UNITED STATES DEPARTMENT OF COMMERCE
Patent and Trademark Office

APPLICATION NO.	FILING DATE	FIRST NAMED INVENTOR	ATTORNEY DOCKET NO.
09/144,920	09/01/98	GRIFFIN	4990.21

Office Action Summary

Detailed Office Action

ATTACHMENT A

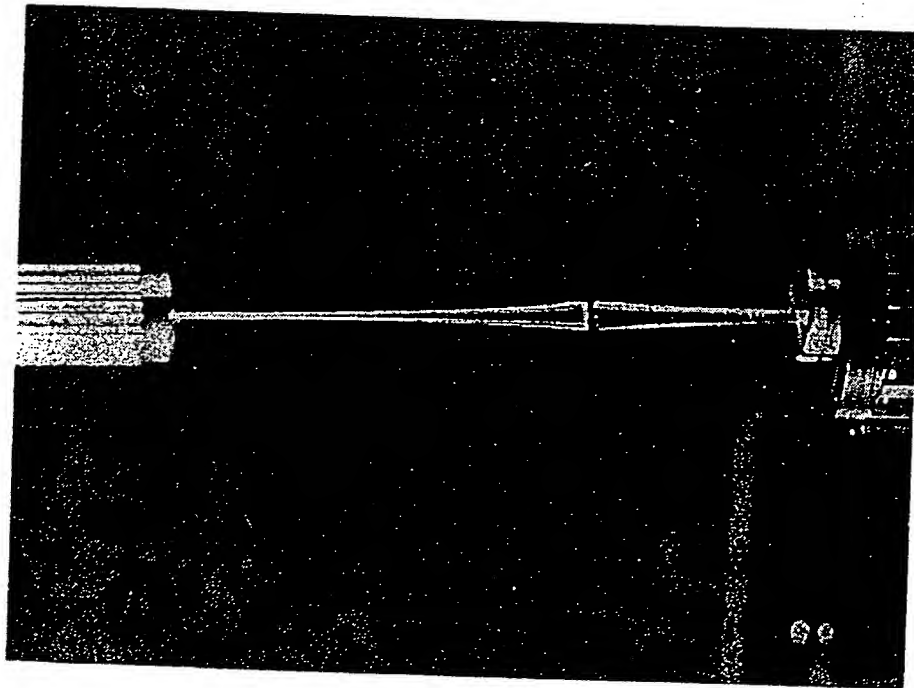
With respect to claim 22, based on the assumption from above, JOLT in January discloses an optical assembly comprising (please see the attachment A): an illumination fiber (fig 9, 1), a first taper fiber section (fig 9,2), a collection fiber (fig 9,4).

With respect to claim 24, the collection fiber section comprising: a second tapered fiber section (fig 9, 3) and the light output end has a smaller diameter than the light input end.

With respect to claim 28, fig 9 in JOLT (please see attachment A) discloses the output of the first tapered fiber (fig 9, 2) and the input end (fig 9, 3) of the collection fiber are coupled to one another.
